Early Design Guidance 2
8.28.2019
3033617-EG
725 Yesler Way

SECTION 03 / EDG-1 Summary of Board Guidance

Summary of Board Guidance

Parking Garage Entrance

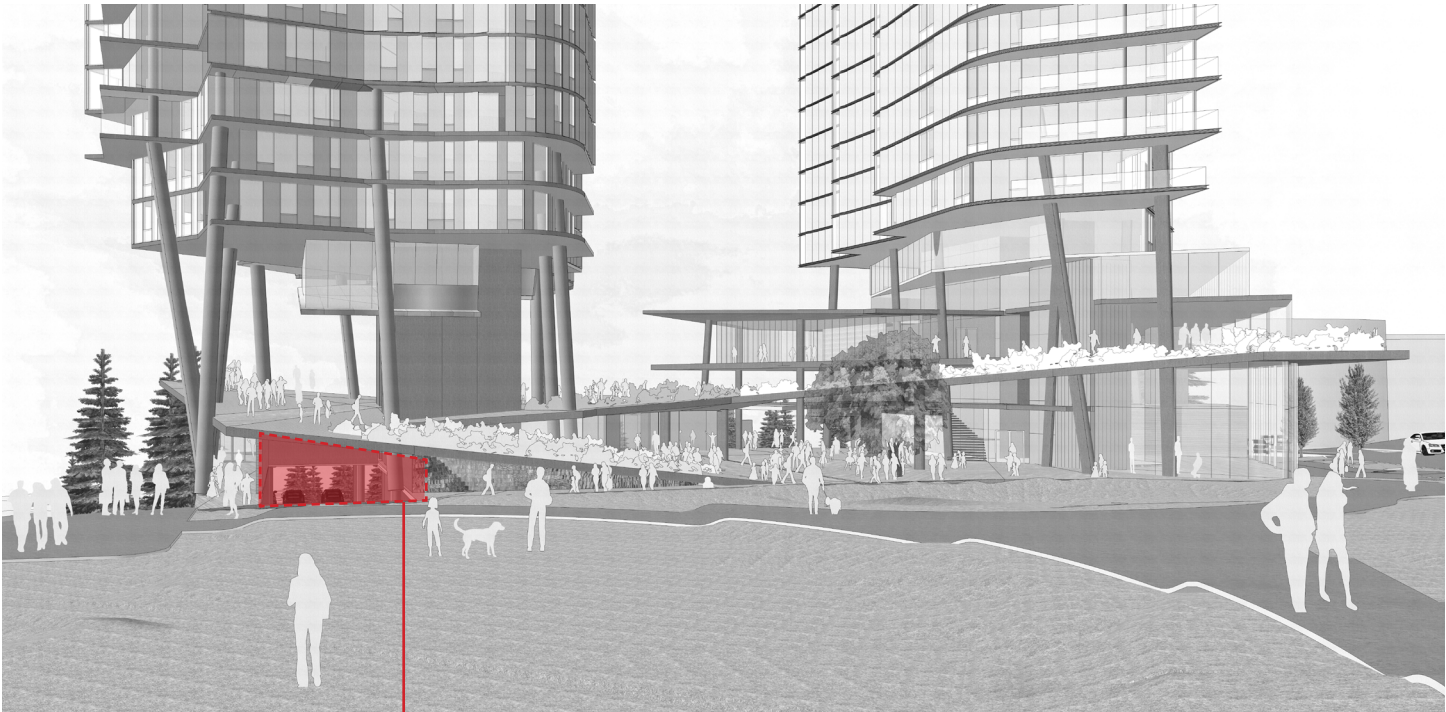
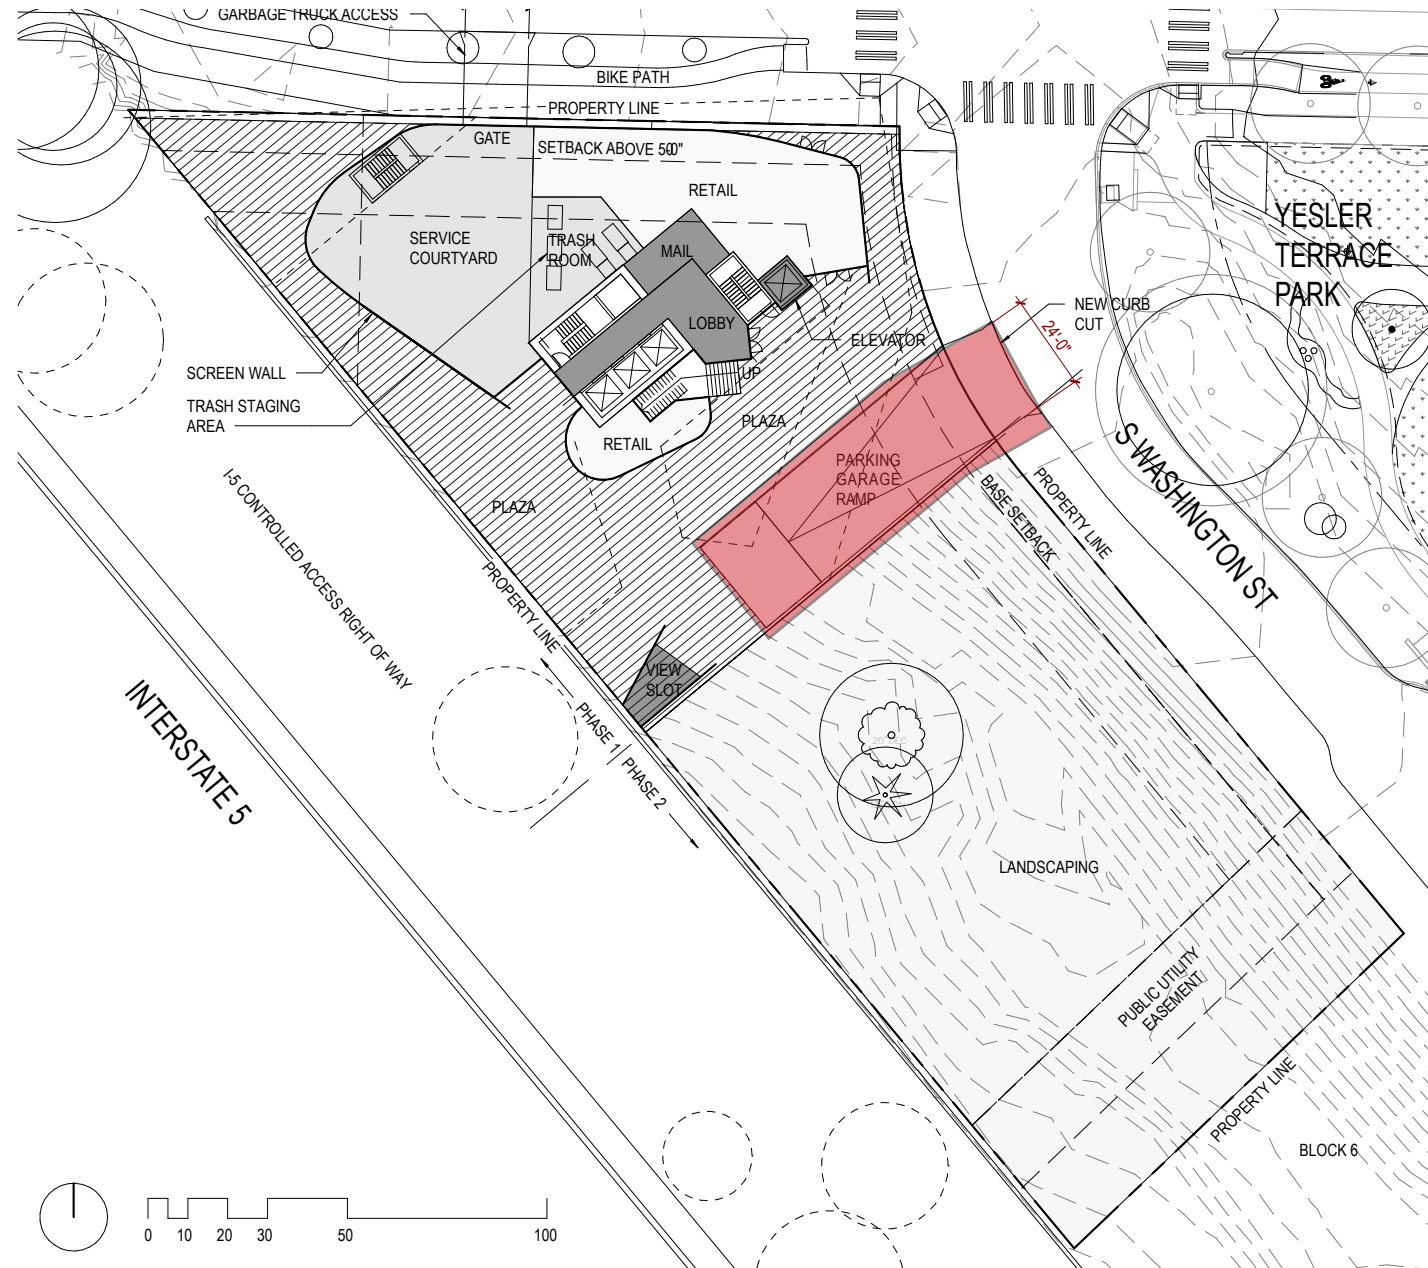
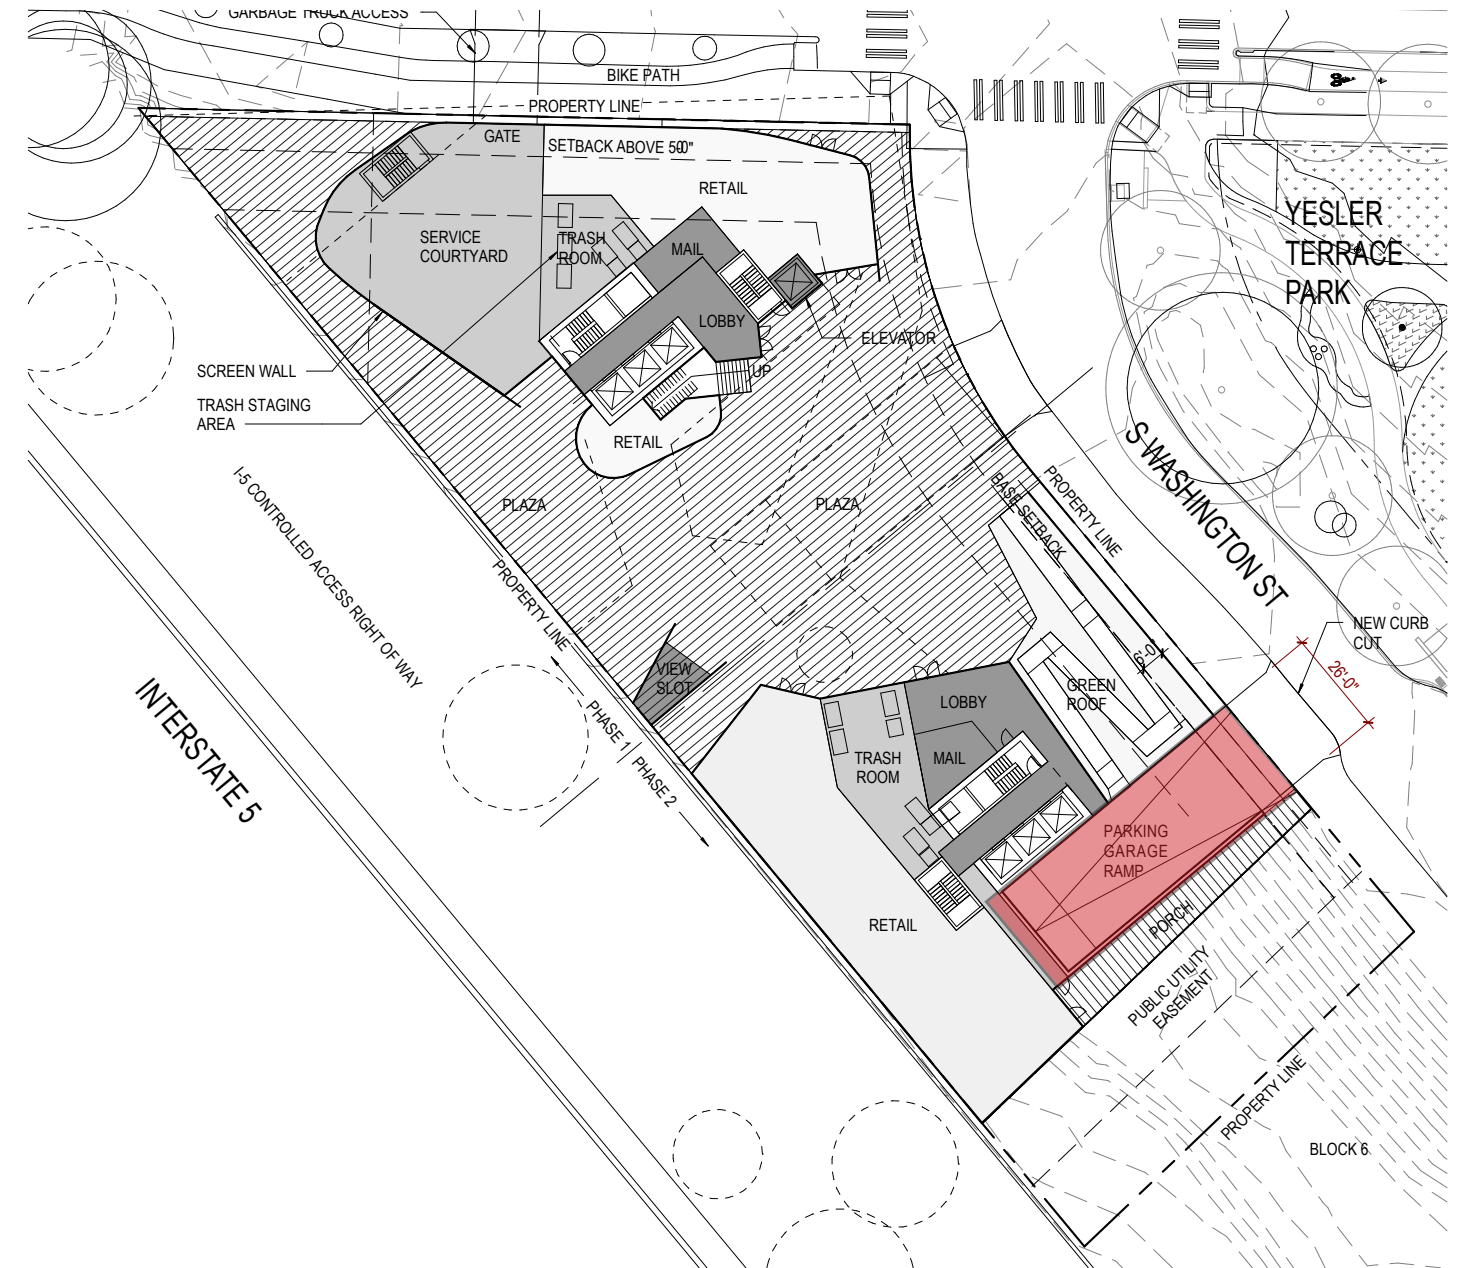
The Board struggled to reconcile the strong open space concept and proposed landscape plan with the location of the parking garage entrance, which is part of Phase 1, near the center of the plaza. This location, as a focal point of the podium, conflicts with the design concept making it a challenge to fulfill the Design Guidelines. As a green street, S Washington St is intended for pedestrian activities. Recognizing the potential financial challenge of moving the parking garage entrance, such as construction of a full garage in Phase 1, the board recommends further study of the entrance location. The preferred location would be at the southeast corner. If this is not viable, the Board would like to see a summary of why this does not work here, as well as study of the entrance pushed to one side of the plaza or other, preferably to the south, so as not to be in the center of the plaza.

The Board agrees with public comment that screening of the garage entrance with art and/or landscaping should be considered.

The Phase 1 parking garage entrance is located at the only viable location to allow for construction of a Phase 2 parking garage and tower in the future. The final parking garage entrance is proposed at the southeast corner of Phase 2 which, once the compete, allows the central parking ramp to be lidded over and the space integrated into the open-space design. This will create a large plaza at the center of the project that provides generous open space and pedestrian circulation immediately adjacent the public ROW.

Phase 1 Podium Accessibility

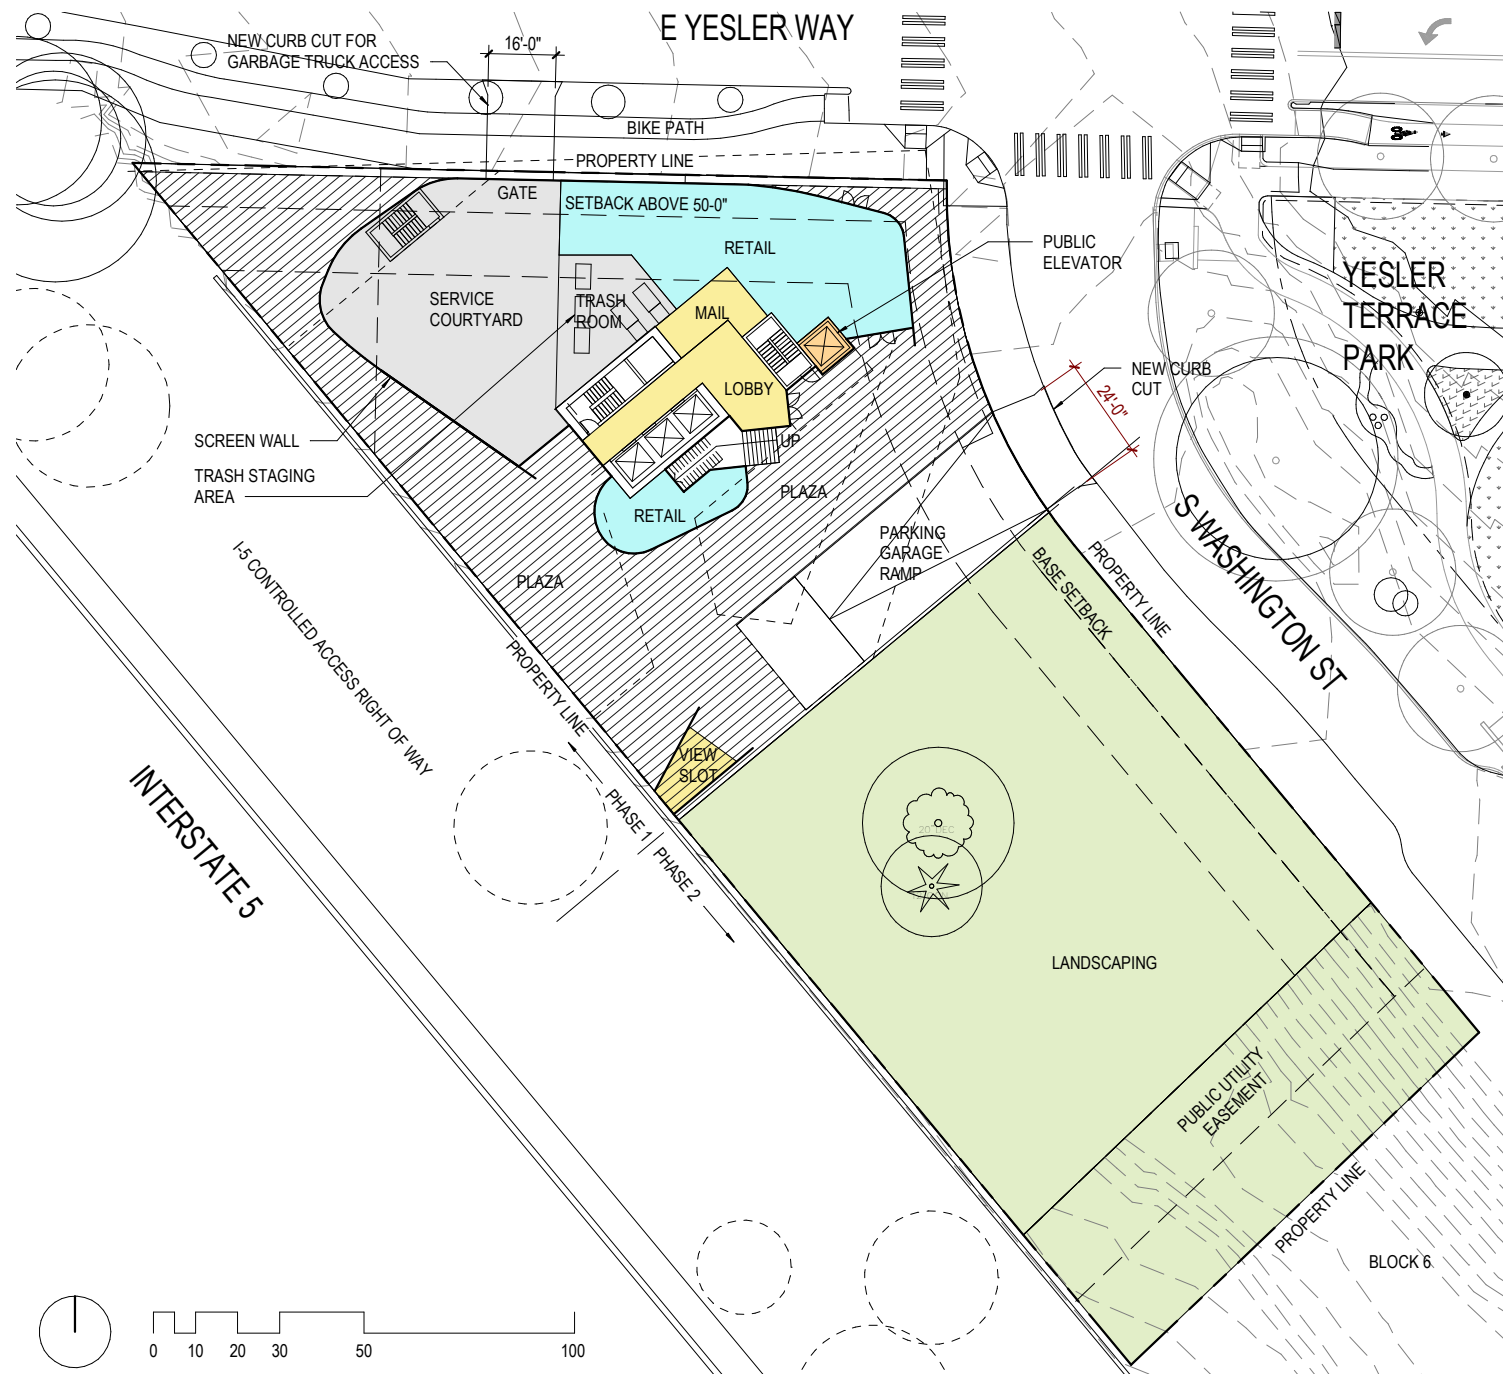
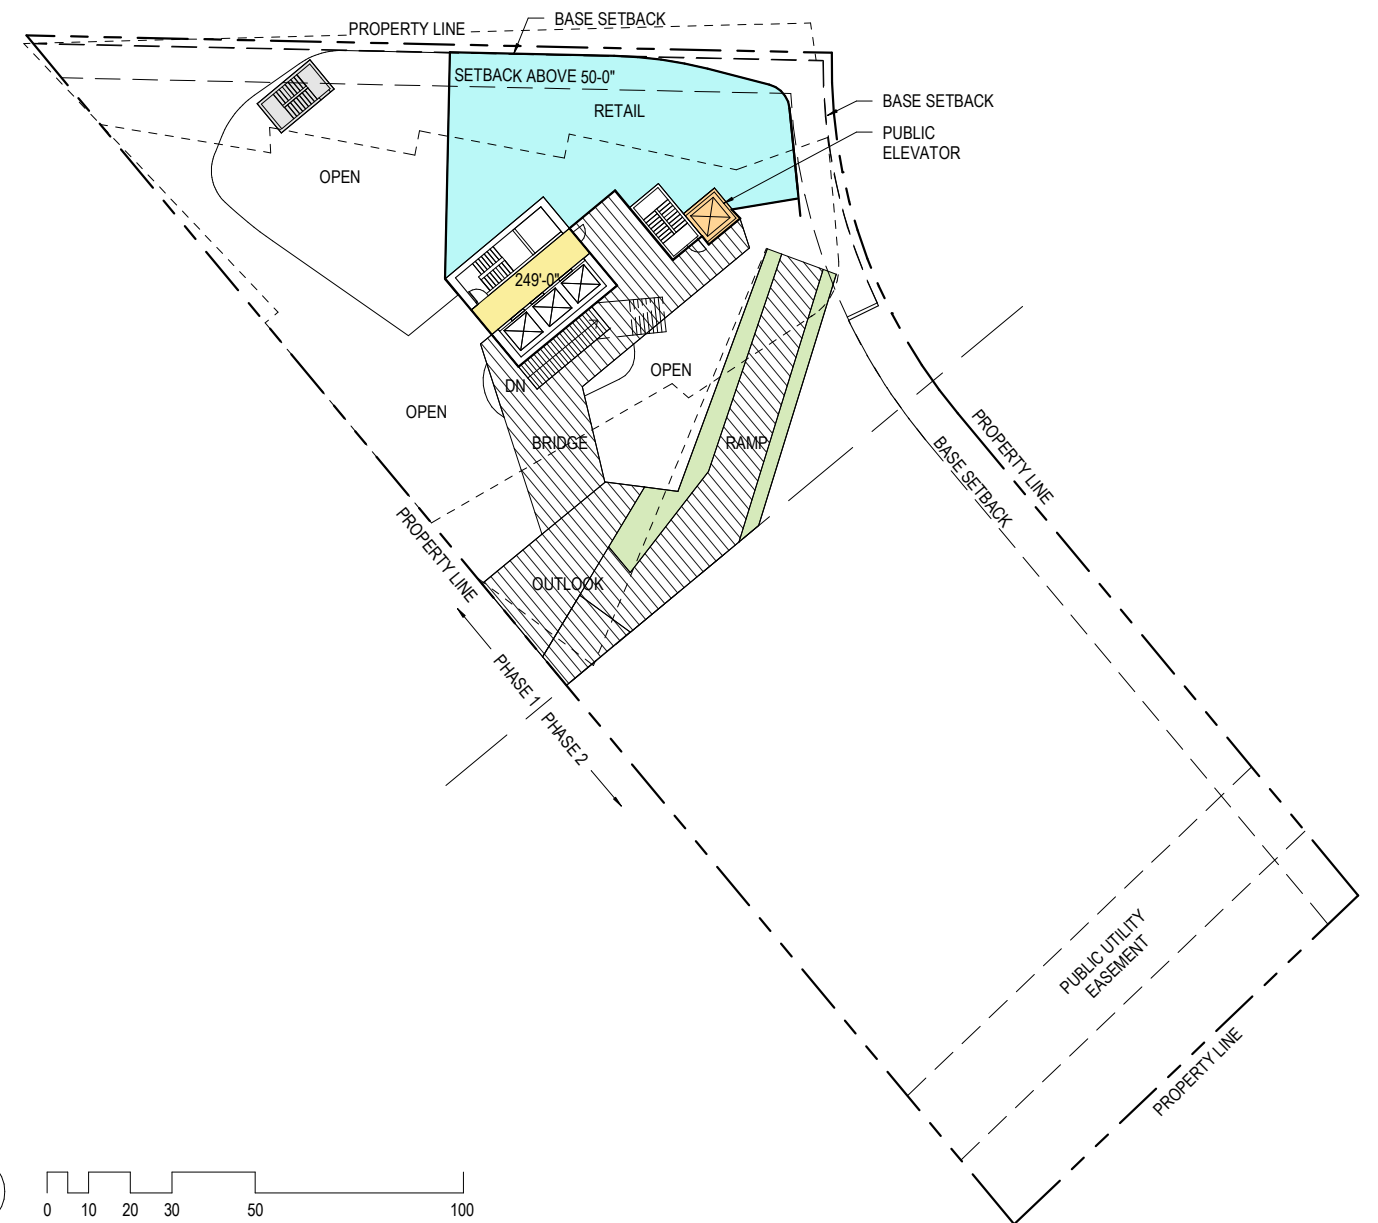
The Board was very concerned with how building the podium into two phases would impact the accessibility of the elevated open space in the first phase, as well as how the phase 1 podium expression would read as a stand-alone design. The Board requested illustrations of the Phase 1 podium design.

The circulation concept for the Phase 1 podium is to have a spiraling stair / ramp publicly accessible up to Level 3 that is highly visible and intuitive when approaching from the east ROW and neighborhood. Stair access would extend from the retail parking in the garage up to the plaza level and continue to the elevated terrace at Level 2. From here an accessible ramp extends to outlook points and a public gathering room. A public elevator connects all levels. The views from level 1, 2, and 3 in Phase 1 will have the same orientation as the full Phase 2 build out.

- Public Gathering Room
- Elevated Terrace at Level 2
- Public Elevator
- Public Stair
